CITY OF ALBUQUERQUE

**RE: Arroyo Vista Median Swale
Grading and Drainage Plans
Engineer's Stamp Date: 06/6/19
Hydrology File: J08D005, CPN 651182**

Subject: Arroyo Vista Median Swale

Updated exhibits based on comments

INSPIRATION SUBDIVISION
PROPOSED BASINS MAP

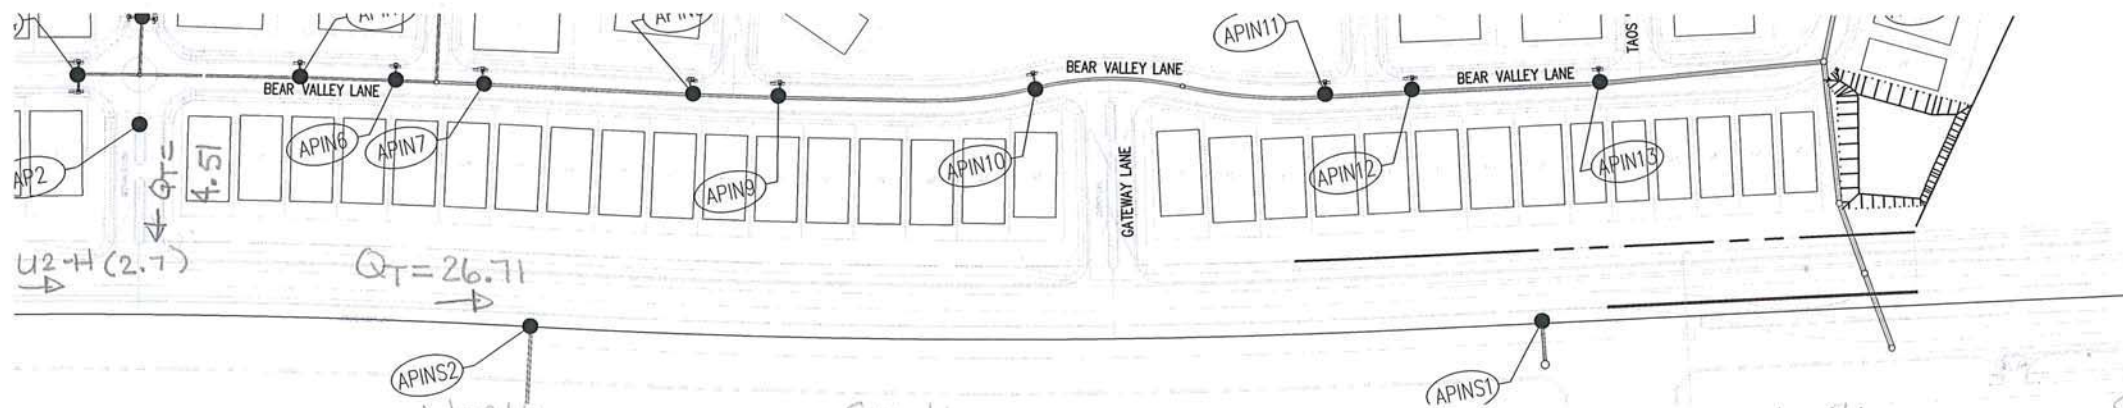
2. From a site visit it appears that 2/3 or so of Basin OS-2 drains to Basin U2-H before entering Arroyo Vista Blvd ROW. Grades were altered during wall construction, so existing grades cannot be used. In addition, the land was driven/worked on. Please update the basin calcs to 2/3 of 1.36 acres= 0.9 acres and use 100% Type C land treatment. In addition, Basin OS-2 should be broken up into two basins as there are two outfall locations. This would also allow for an "Arrow" showing the outfall location through Basin U2-H.

4. For Basin OS-1, move/point the flow arrow so that it is clear that this basin drains to the arroyo located south of the Arroyo Vista Blvd ROW.

After a site visit, I disagree that 2/3 of Basin OS-2 gets to Arroyo Vista. I stand by my revised calculation that 14% of OS-2 drains to Arroyo Vista with the remaining portion draining over the walls and into the subdivision. However, the 2/3 portion was calculated along with the 14% and are listed below. I have added the 2/3 of Basin OS-2 of 2.6cfs to the inlet location downstream and the inlet can still accommodate this additional 2.6cfs. See enclosed revised exhibits enclosed.

Flow arrow was previous shown just to light. it has been updated to remove previous arrow and darken new arrow

* REVISION 10-6-2022

Inlet Schematic 7

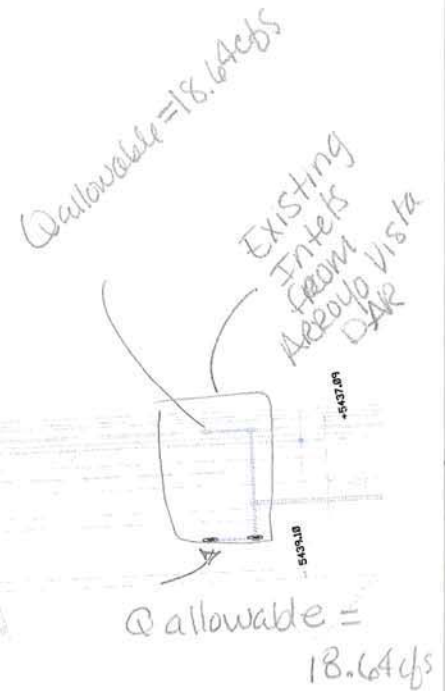
1. Per the DPM Figure 6.9.9, the capacity of a double inlet at 0.7' of depth at 0.2% slope is 10 cfs. The submittal states there is 29 cfs. The inlet appears to be undersized. The city does not count the 'throat' for its inlet capacity as is it there in case the grate plugs, which happened during the storm event referenced above.

3. Update the calculations for the inlet at the east end of the swale with the revised flow rate.

The information you provide is for an inlet that is on-grade. We are in sump condition. The inlet is sized adequately in sump. We prepared a side weir calculation that indicated 16' of width of curb needed to be removed to pass the flow into the location of the sump inlet. I have attached the submittal and approval to this letter.

See response above and exhibits enclosed.

* 31.59 cfs

* REVISION 10-6-2022

Inlet Schematic 7

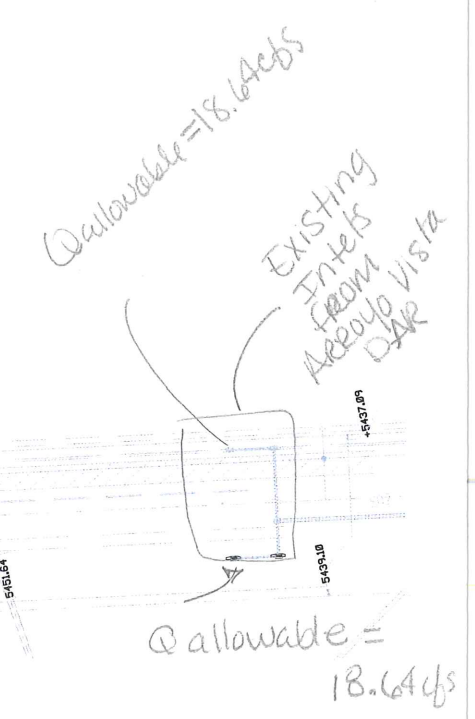
I have been looking at this and could you possibly see if you can darken up sheet 2 of the package you sent. I have had a hard time reading the handwritten notes on there. I am inclined to allow this but I want to make sure I have all the info laid out.

This is good. Much better. I had looked this over and I am giving Hydrology approval of this.

Hi Ernest. Is this better? I can try again if you want it darker still.
